**Register Reference:** SDZ22A/0017 **Date:** 03-Jan-2023  
**Development:** Construction of 157 dwellings within the Clonburris South-West Development Area of the Clonburris Strategic Development Zone (SDZ) Planning Scheme 2019 consisting of, 81 houses comprising of 4 two bedroom houses, 65 three bedroom houses and 12 four bedroom houses (all two storey with associated private open space and car parking; 76 apartment units consisting of 26 one bedroom and 50 two bedroom units within Block 1 (4 storeys); Vehicular access will be provided from the permitted street under SDZ21A/0022 and the permitted Clonburris Southern Link Street (SDZ20A/0021) and R113 (Fonthill Road) to the east; All ancillary site development works including footpaths, landscaping boundary treatments, public and private open space areas, car parking (170 spaces) and bicycle parking (170 spaces), single storey ESB sub-stations, bin and bicycle stores and all ancillary site development/construction works all on wider lands bounded generally by the Dublin-Cork railway line to the north, undeveloped lands and Grand Canal to the south and undeveloped lands and the Fonthill Road (R113) to the east, in accordance with t

Figure 1.2.1 – Street hierarchy layout from SDZ

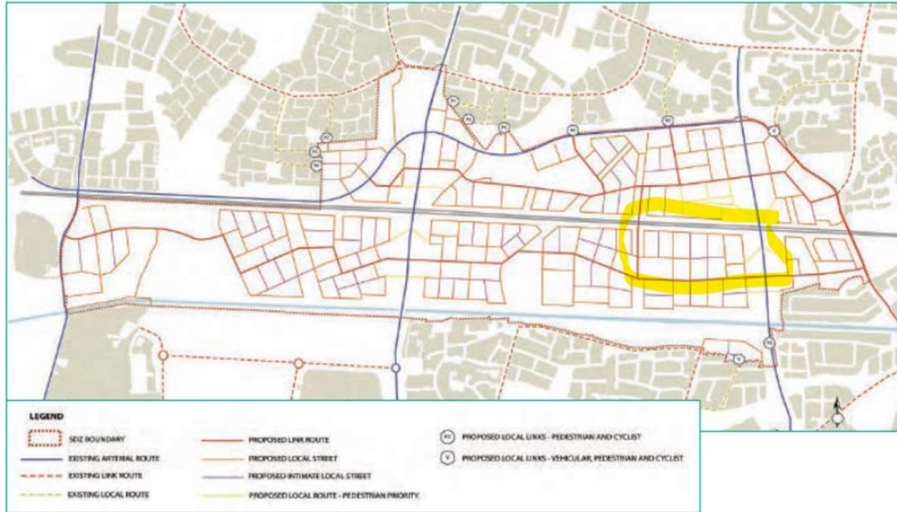
The roads hierarchy layout conforms in the main to the SDZ framework plan with a notable exception being the link street 18 (marked with an X below) is proposed as a 'local street' and not an 'intimate street' as per the SDZ layout.

Applicant is required to provide a justification for this departure from the Clonburris planning scheme framework. If there is no justification for the change, the applicant must submit a revised layout that reflects the Clonburris planning scheme framework.

1. Re road hierarchy/Street 18: Applicant is required to provide a justification for this departure from the Clonburris planning scheme framework. If there is no justification for the change, the applicant must submit a revised layout that accurately reflects the Clonburris planning scheme framework.

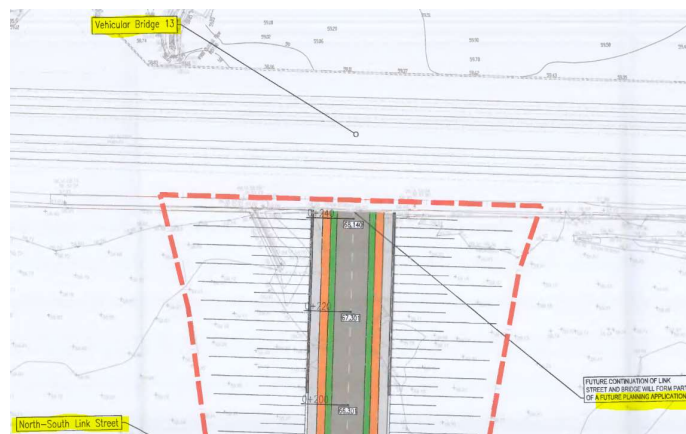
The granted “North-South Link Street” (SDZ20A/0021) makes provision for an **approach** to a vehicular bridge spanning the adjacent rail line. The green corridor, including cycletrack and footpath, on the southern rail boundary must continue through the subject site and links to cycle and pedestrian underpass must be provided and consistent with the existing and future permission (see diagram below). Applicant will be required to engage with all relevant bodies (TII, NTA, SDZ20A/0021 applicant, etc) and to submit plan, elevation & cross-section drawings of proposed vehicular bridge including cycle and pedestrian underpass detail, and associated public lighting, and to provide links from the subject site accordingly.

**Reason:** To ensure continuity of green corridor and safe passage for all users.

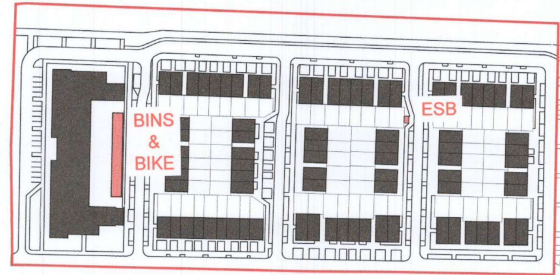
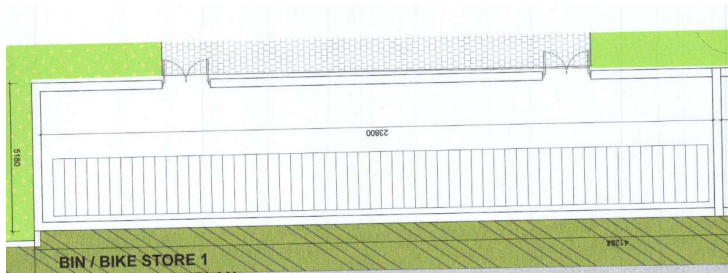
A total of 170no. car parking spaces (50no. apartment, 60no. on street & 60no. on curtilage) are proposed.

The maximum number of carpark spaces allowed for this development under the CDP 2022-28/Clonburris SDZ planning scheme would be 169.5no. The applicant has proposed 170no. spaces which SDCC Roads find to be satisfactory.
